Application Number **P24-26**

P24-26
West Smith Road New Home

Property Owners: James and Elizabeth Vanderpool
Applicant: John Potter
Location: 322 West Smith Road
Zoning: C-2 (Central Business)
Request: Certificate of Appropriateness approval for a two-family home in the TC-OV District

OVERALL SITE PLAN

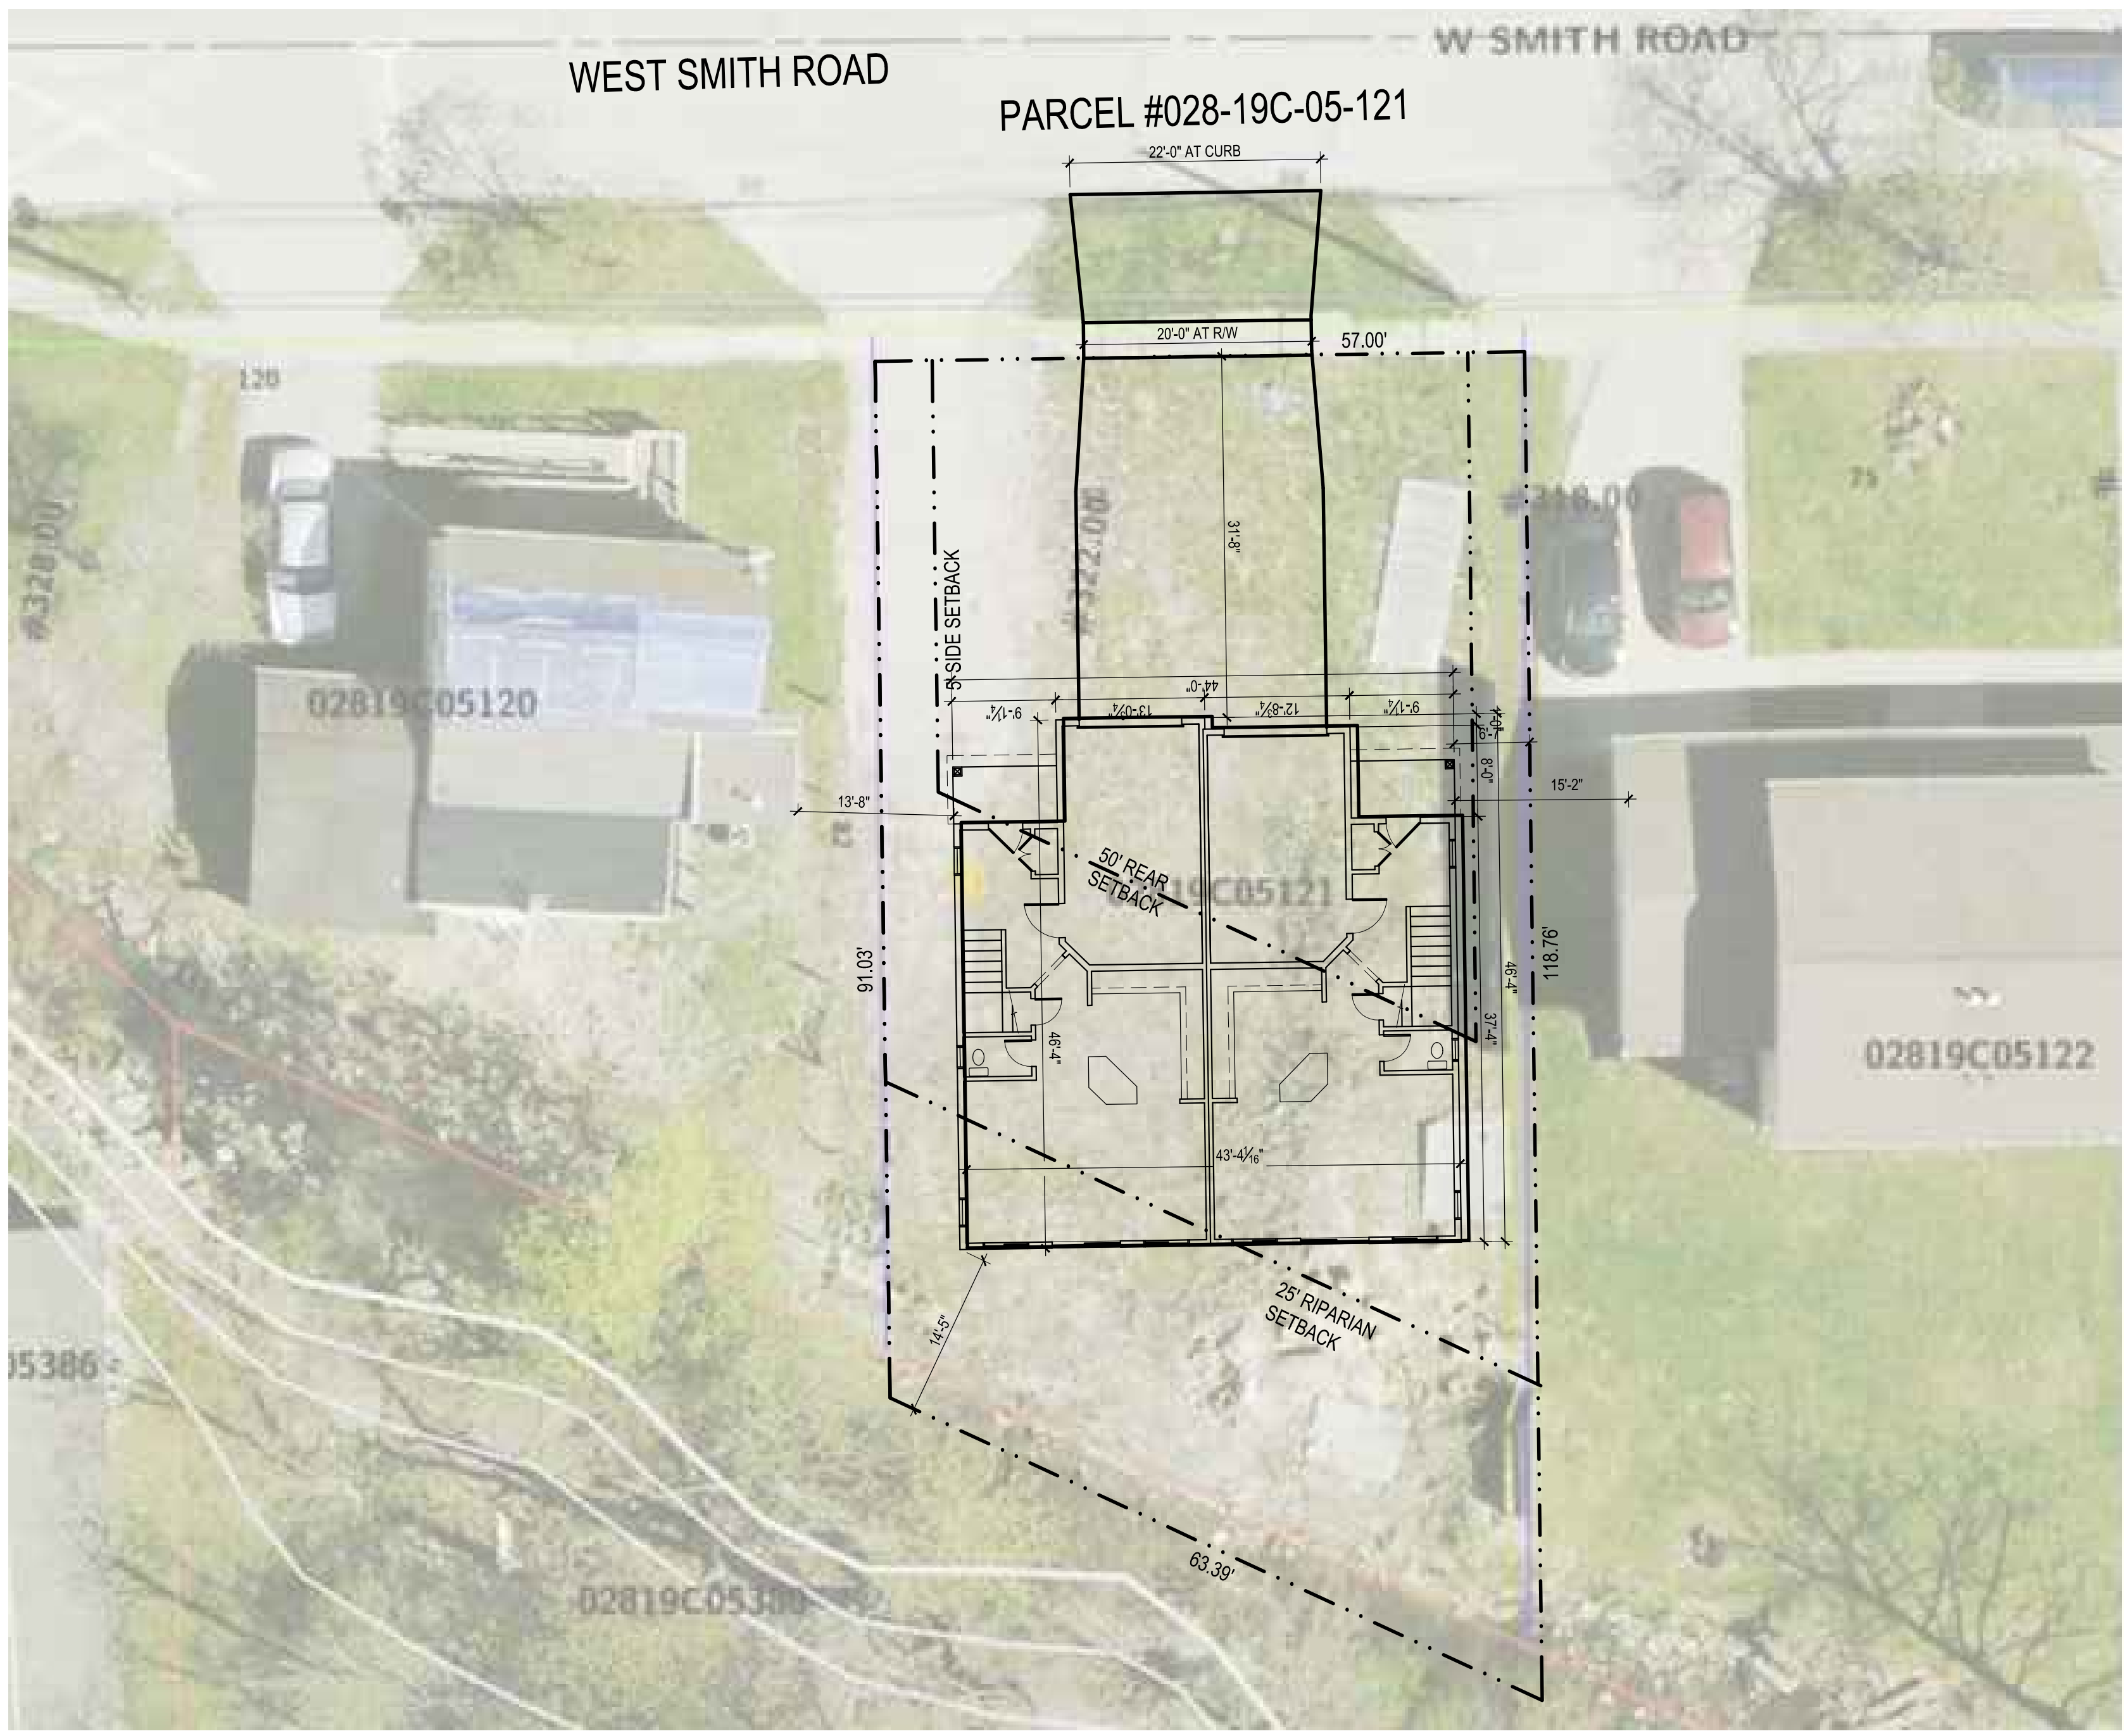
The proposed site plan does not meet the required 50 ft. rear setback and proposes parking in the front yard. The applicant has filed a variance to Sections 1135.06 and 1135.08(a) to allow a reduced rear yard setback and parking in the front yard, respectively.

Though a 25 ft. riparian setback is shown on the submitted plan, the setback is a recommendation by the City’s Engineering Department and is not a formal requirement.

Staff recommends approval of application P24-26 as submitted with the condition that the project shall receive variance approval from the Board of Zoning Appeals to Section 1135.03 regarding use, Section 1135.06 regarding the rear yard setback, Section 1135.08(a) to allow parking in the front yard, and Section 1135.13(c)(1) regarding the use of vinyl facing the right-of-way.
